Lesson to be learned in public presentations

General Description of Plant Fill Problem and Its Extent

List of Vu-graphs for ACRS Presentation - Geotechnical Engineering

GES-1

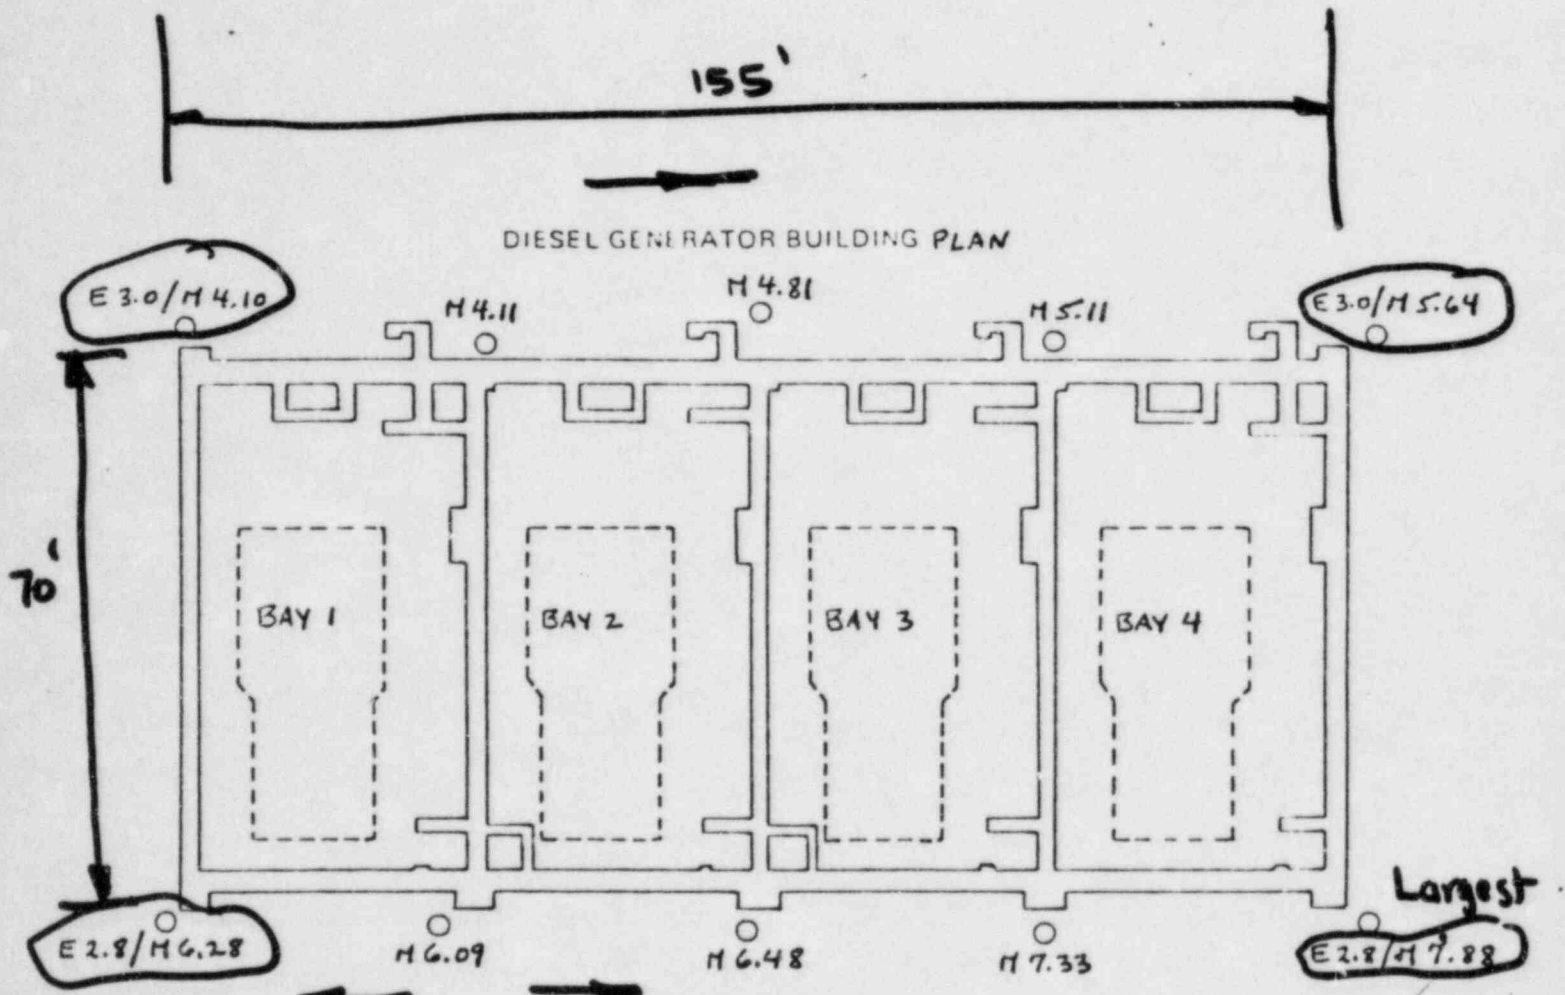
see same cut I
 Show structures on
 natural soils & on plant fill
 Imp't. Elevations
 Plant grade El 634
 Top of natural soils El 600
 Top of hard-stiff competent
 penetration clay, El 585 to 600
 Bedrock is quite deep (4th SHALE)
 ~ El 240 ±

ESTIMATED VERSUS MEASURED
SETTLEMENTS

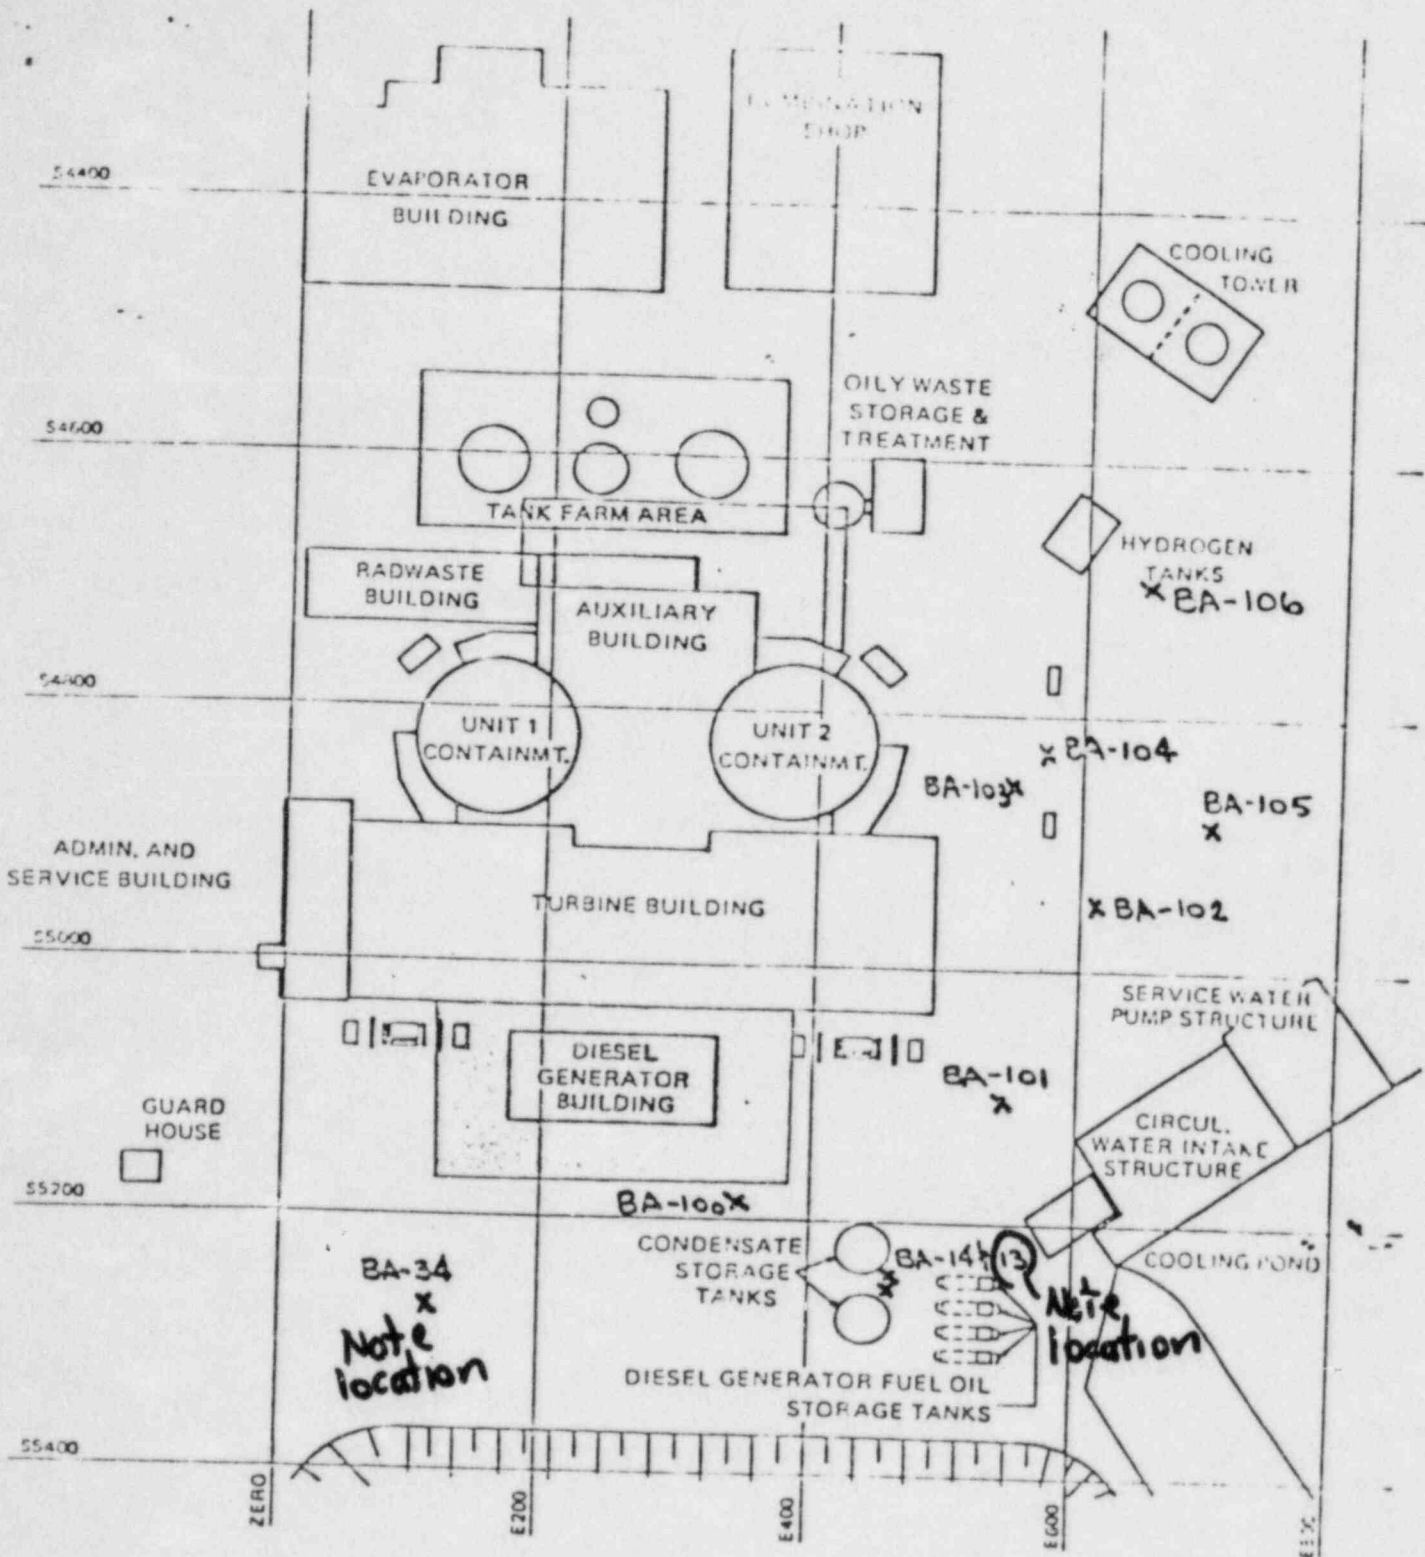
Basis for concluding we have plant fill problem

Some structures have experienced larger than anticipated settlements

DGB - comparison of estimated versus measured

Largest
Include
settlements
under
surcharge

SETTLEMENT OF PLANT FILL UNDER ITS OWN WEIGHT

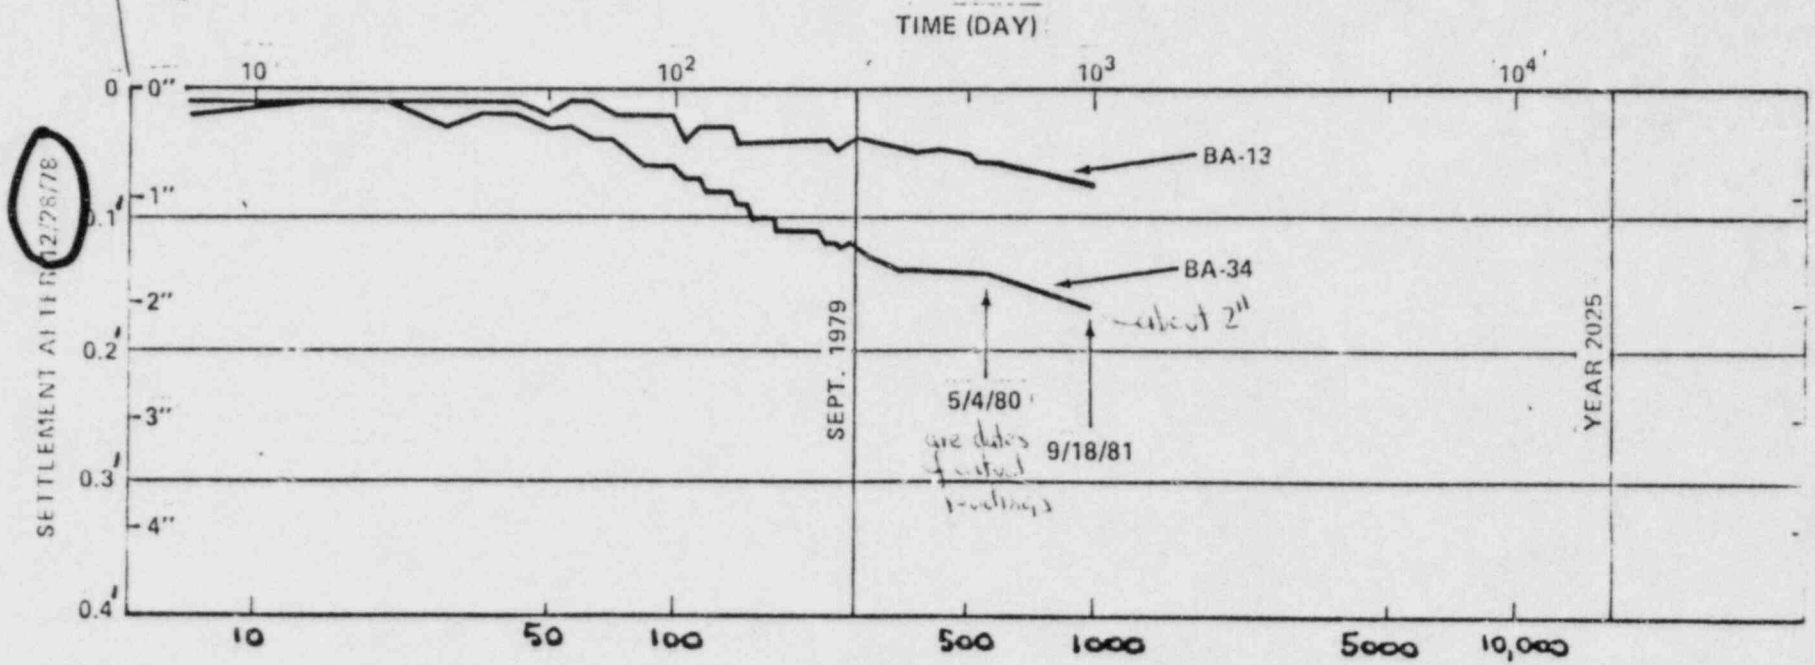
Fill reached plant grade
in 1977 (one year later
when settlement was measured)

Reason for difference in settlements (BA-13 & BA-34)
is likely due to the highly variable fill densities

PROFILE 8"-1HBC-81

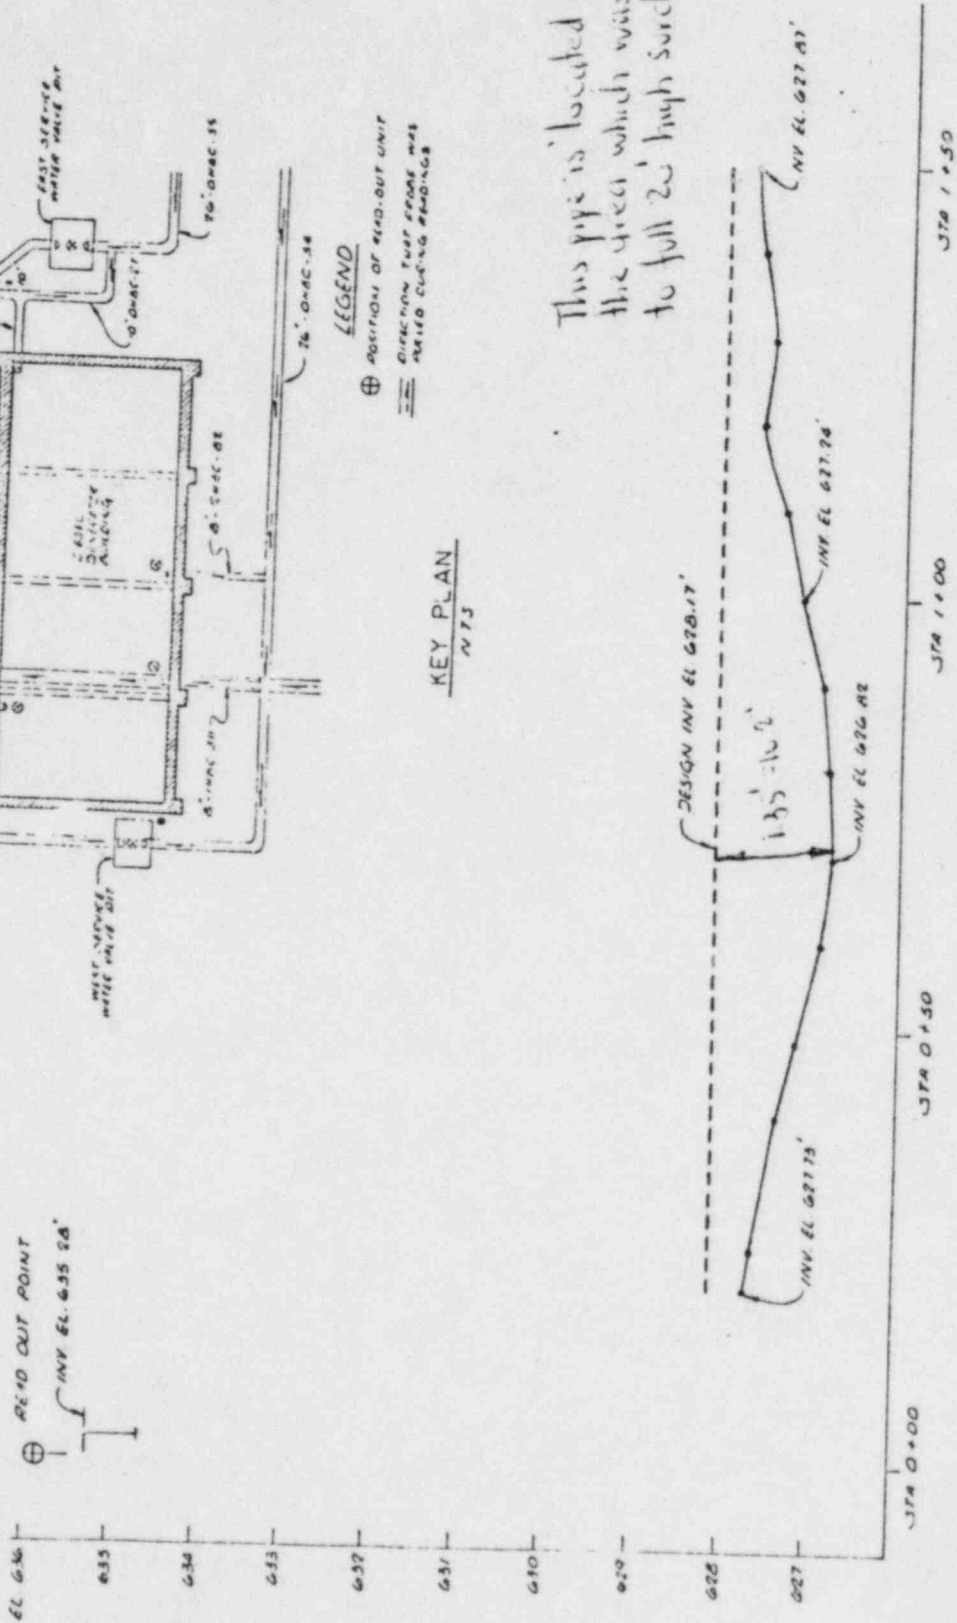
This pipe is located within the area which was subjected to full 2' high surge

GES-6

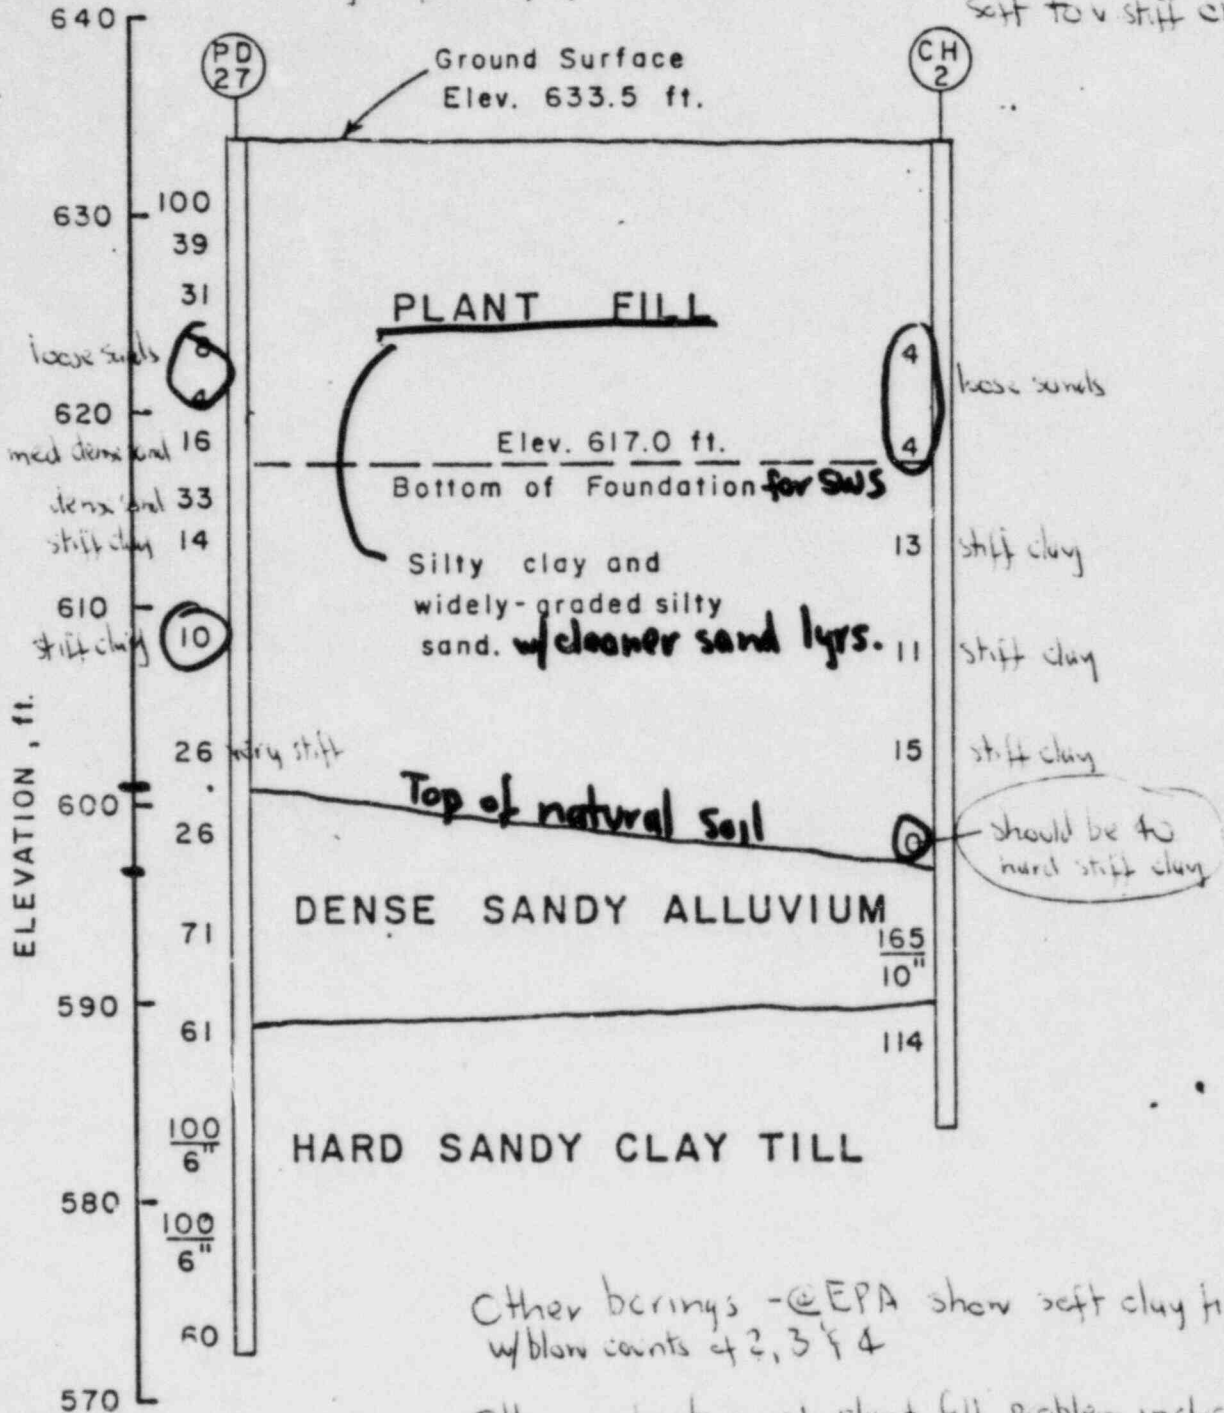
In addition to settlement records we have results of extensive subsurface exploration program that was undertaken in late 1978 after discovery of DGB settlement problem

Borings reflect highly variable fill consistency - loose to v dense SANDS soft to v stiff CLAYS

Other borings - @EPA show soft clay fill w/ blow counts of 2, 3 & 4

Other indicators of plant fill problem include cracking of structures (e.g. BWS Ring beam fdr.), results of plate load test and re-examination of compaction control records

PLAN OF POWER BLOCK
SETTLEMENTS (FEB, 1976) THROUGH AUG., 1981

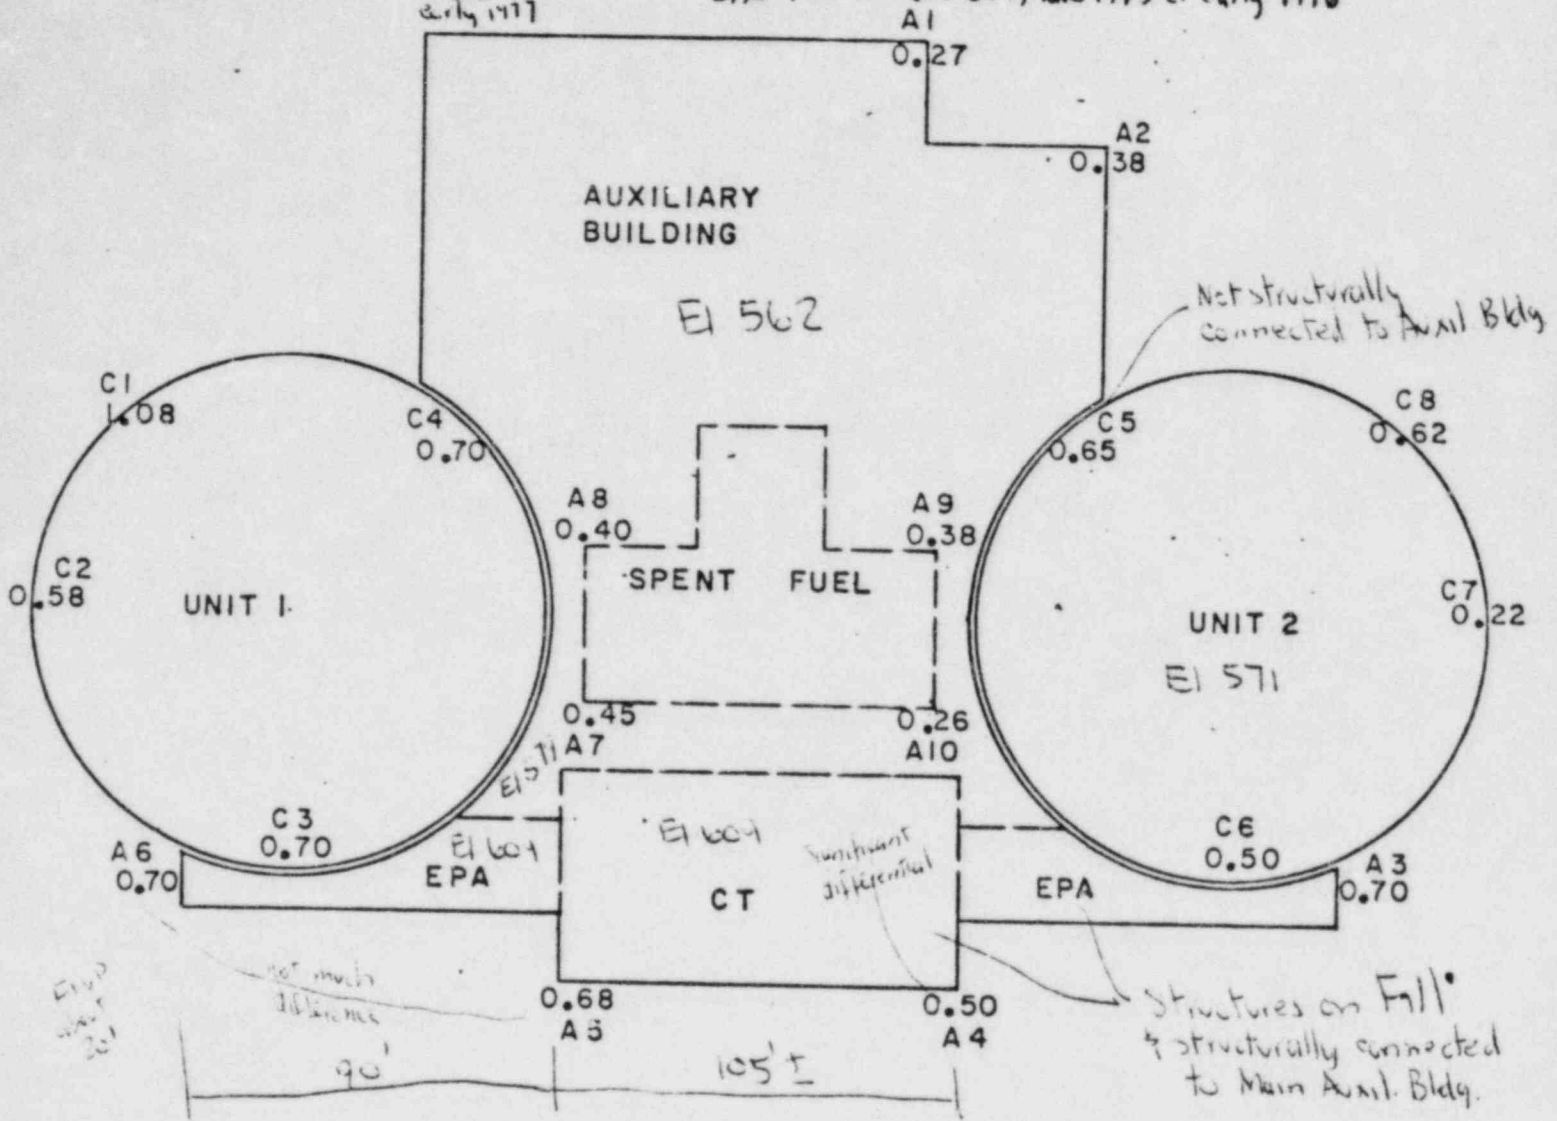
CORRECT

JULY 1978

ask Applicant to respond to settlement records in this area go back this far
